#35/13-01J 12 East Lenox Street
(Chevy Chase Village Historic District)

SUBJECT: Historic Area Work Permit HPC# 35/13-01J DPS# 245821

Address:	12 East Lenox Street, Chevy Chase	Meeting Date:	05/09/01
Resource:	Contributing Resource Chevy Chase Village Historic District	Report Date:	05/02/01
Review:	HAWP	Public Notice:	04/25/01
Case Number:	35/13-01J	Tax Credit:	None
Applicant:	Justin and Elizabeth Bausch	Staff:	Michele Naru
PROPOSAL:	Rear addition and alterations	RECOMMEND:	Approval w/cond

PROPOSED WEST ELEVATION

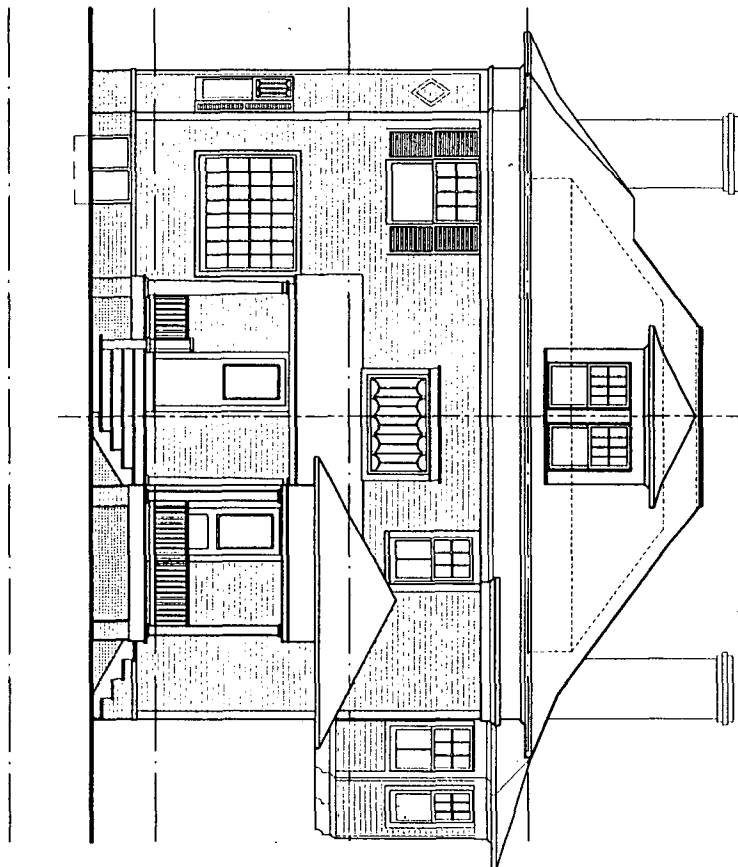
Attached is the revised west elevation of the Bausch Residence showing the proposed changes we discussed on the phone this morning.

The design of the first story roof on the west elevation is problematic from a preservation point-of-view. The design extends the roof slope onto the original massing of the house. When looking at additions to historic structures, the goal is to provide a clear differentiation from the original massing and the new addition. Staff is requesting that the roof slope not extend beyond the vertical trim board on this elevation to provide a clear delineation between the historic massing and contemporary addition.

changes are ok!

Staff approval.
(M)

PROPOSED (BROOKVILLE RD.) EAST
 ELEVATION
 scale 1/8 = 1' 0" 04/18/01

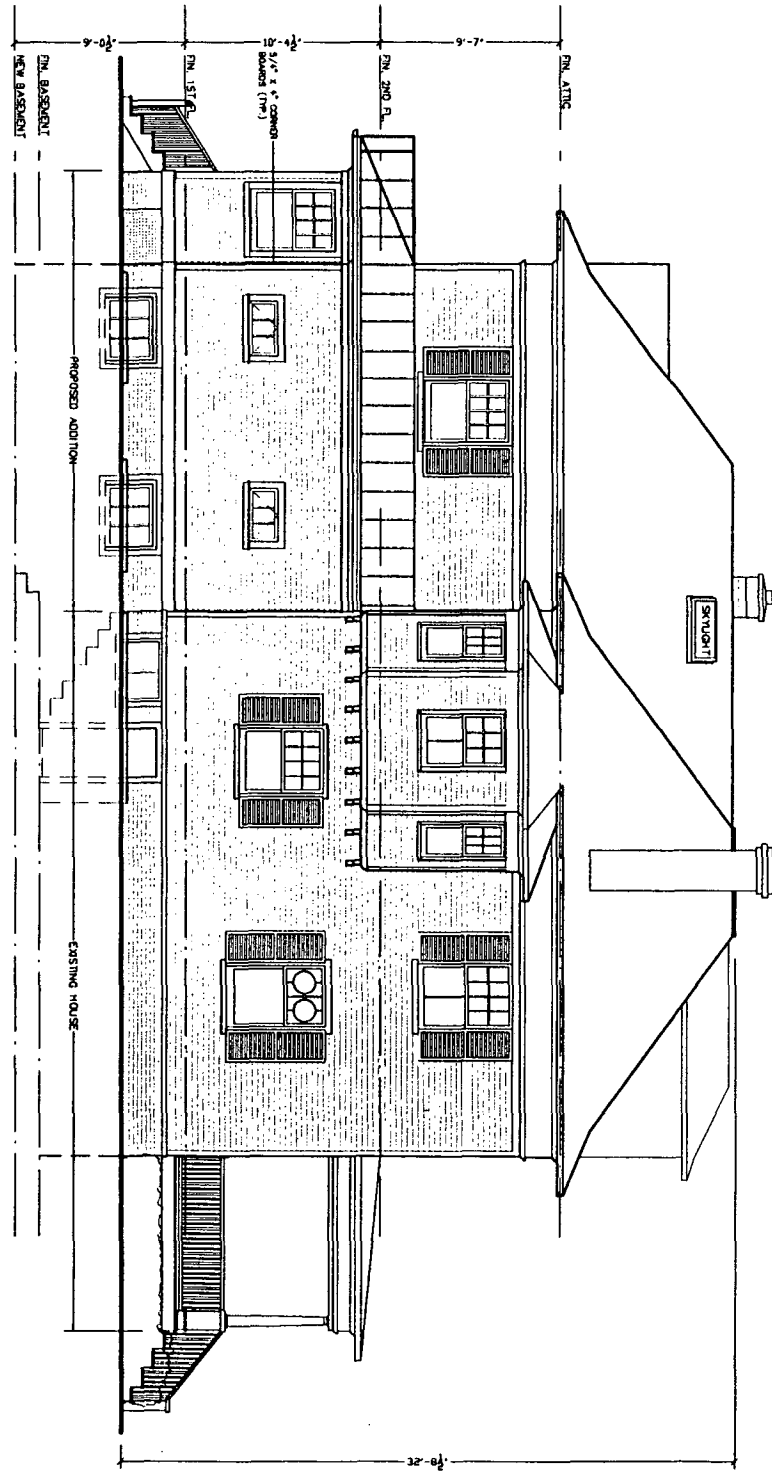
The proposed addition is located at the rear of the house. The east elevation of this addition, which faces Brookeville Road is only expanding in length by 6' and with the significant set-back of the second floor, staff feels it will have a modest effect on the streetscape of Brookeville Road. Staff is concerned with the design of the windows on the kitchen wall of this elevation. Staff feels that the use of awning windows does provide differentiation – yet is of the opinion that the uniqueness of these windows will draw attention to the addition and away from the historic massing of the house. Staff would suggest changing these windows to a single, 8/1 or 6/1 window to be offset to the south.

The proposal includes the installation of a skylight on the 2nd story roof slopes of the east and west elevations of the new addition. Generally, the Commission does not approve skylights on elevations that are visible from the public right-of-way. Staff is requesting that the skylight on the east elevation be removed from the scope of the project.

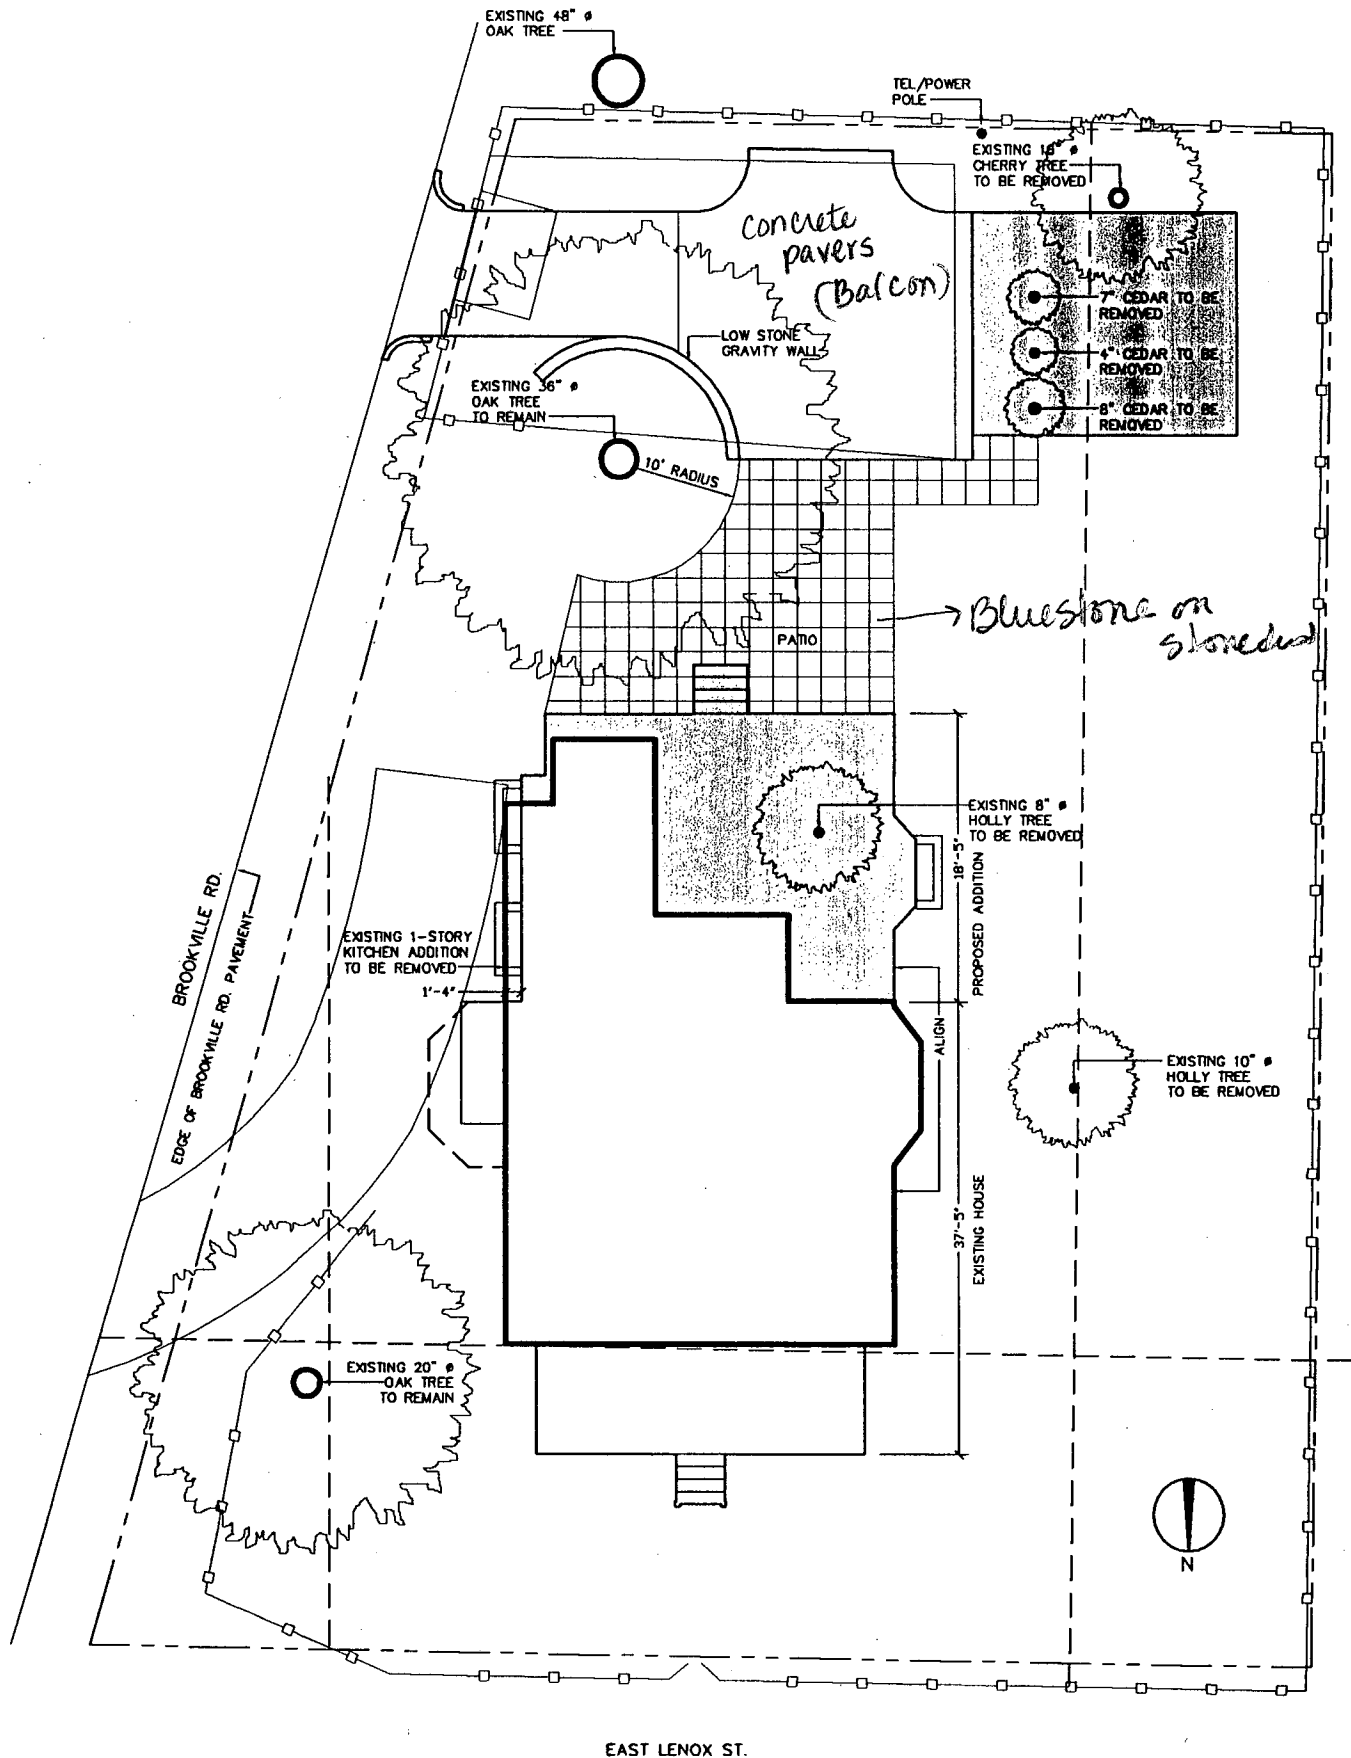
~~10~~ more trees
planted on site

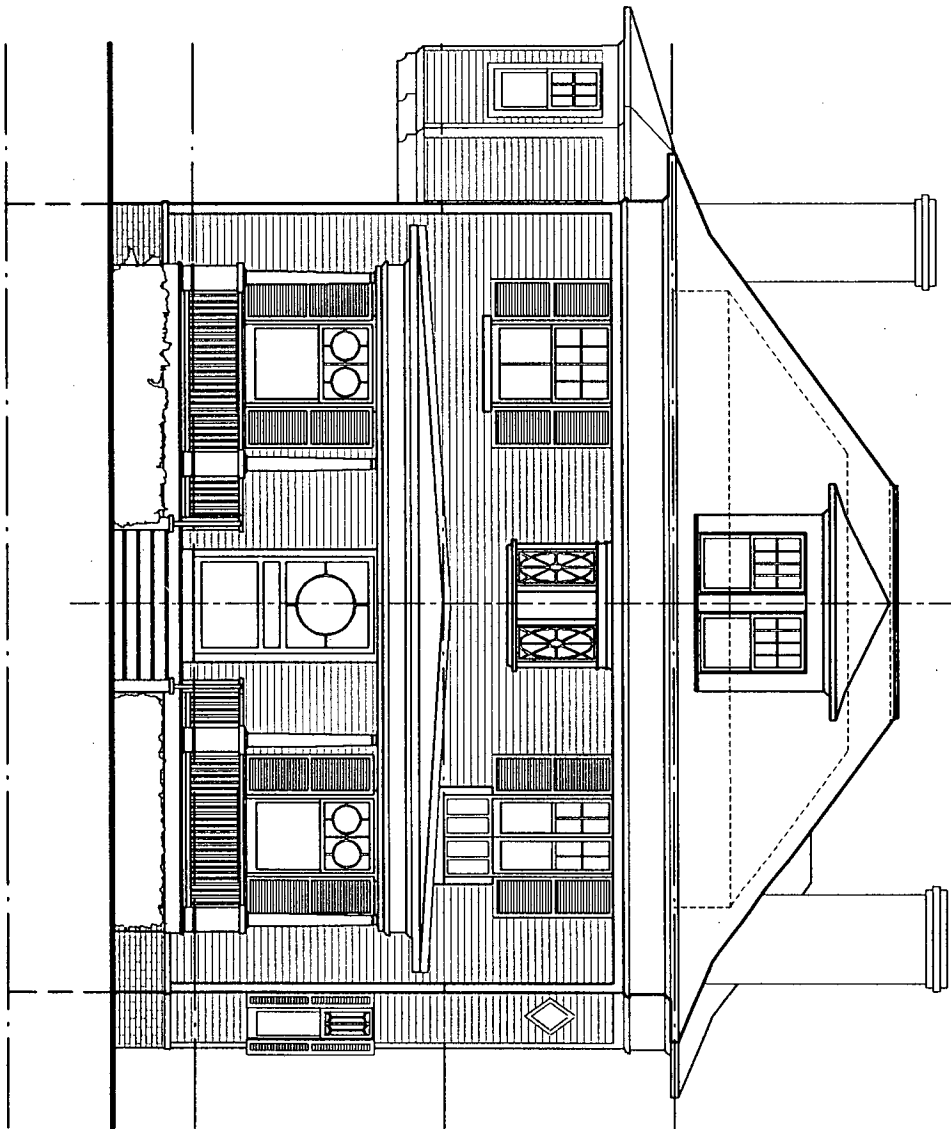
No projection on
roof into
original historic
section.

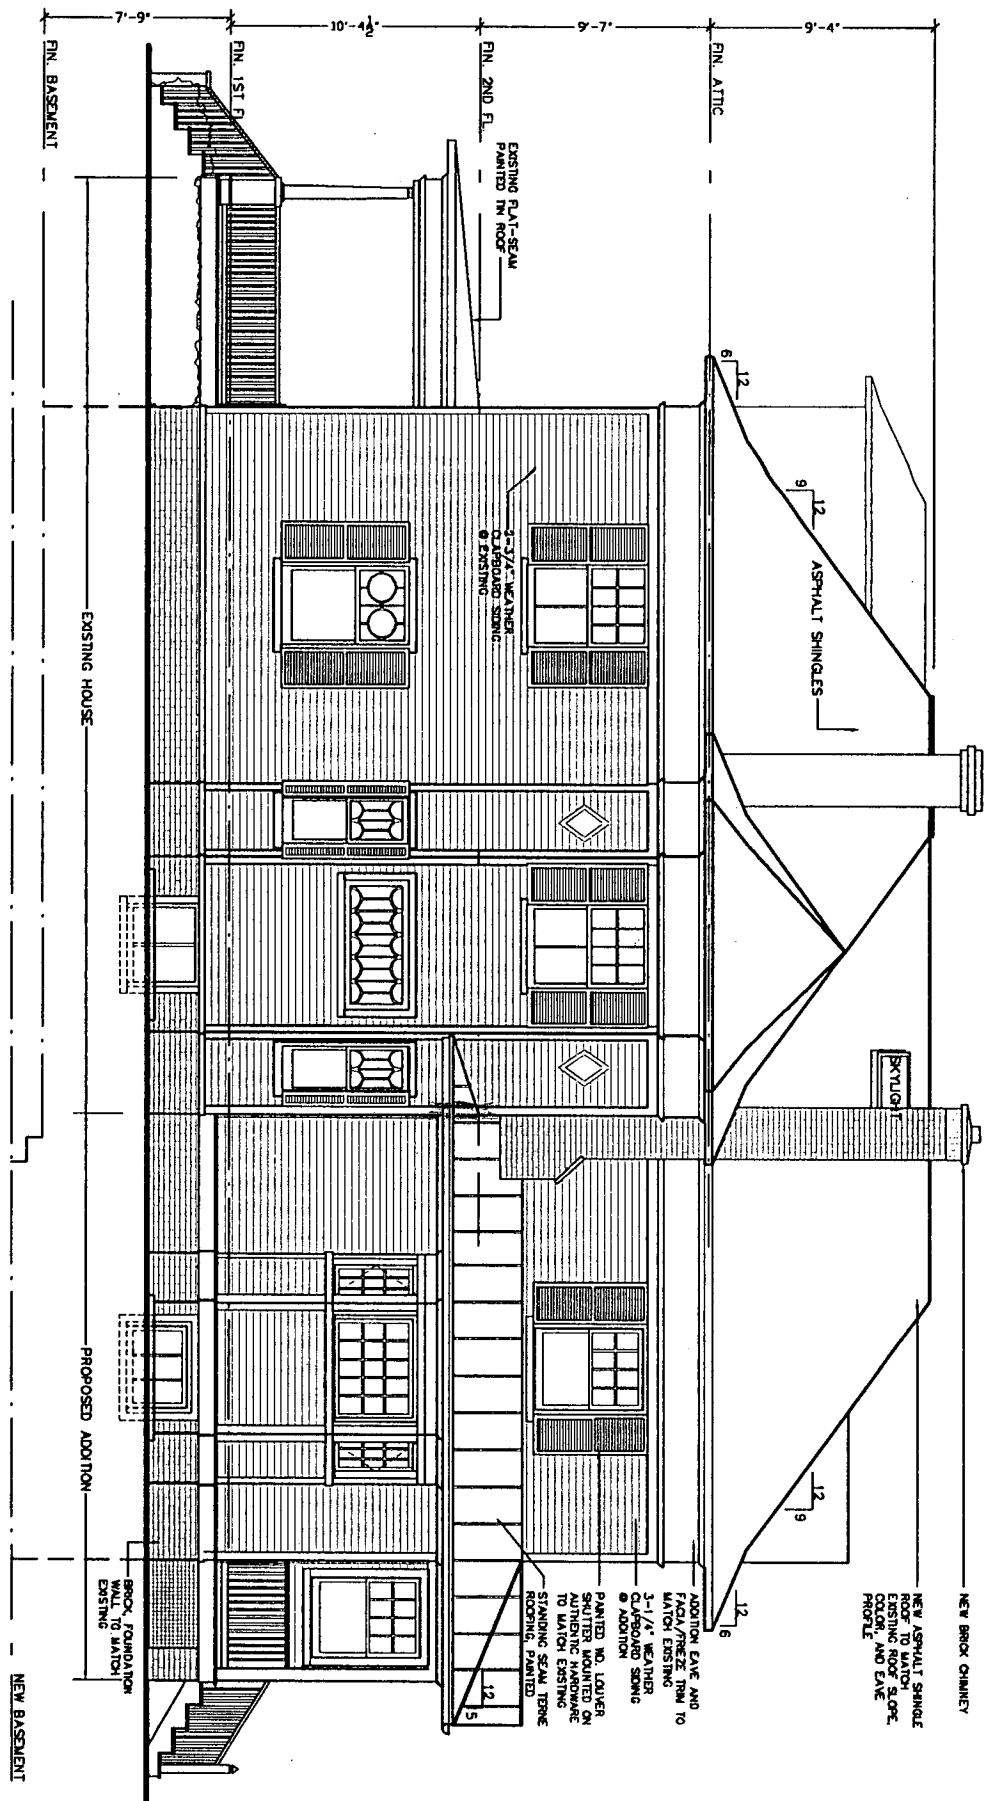
Skylight S -
Keep

porch columns
square
differentiation

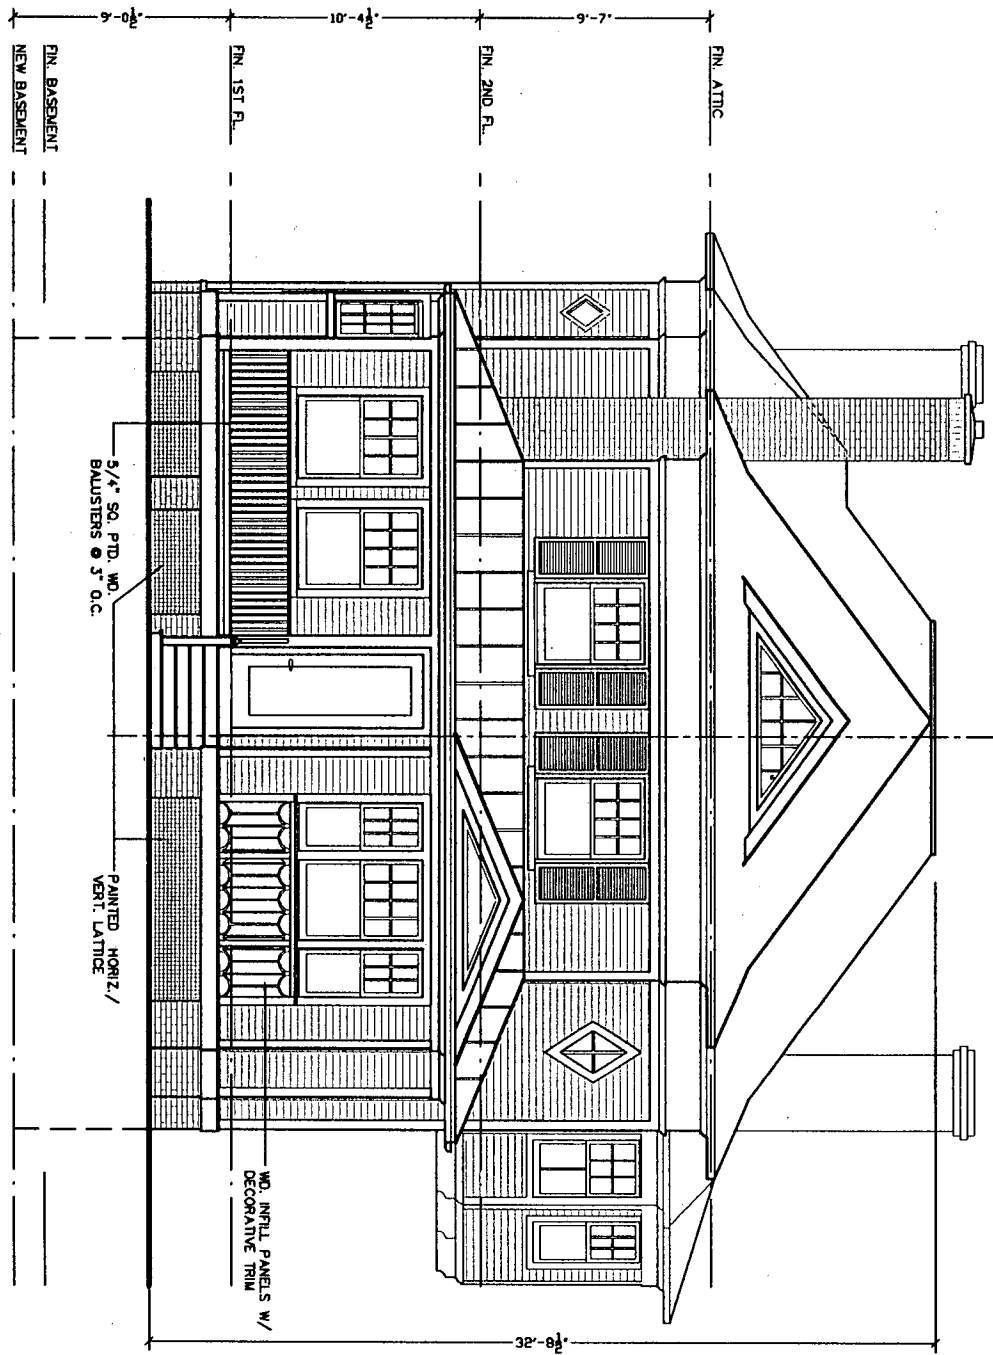
Commission

discussion

on windows

on kitchen.

→ one 1/1 offset

to south.
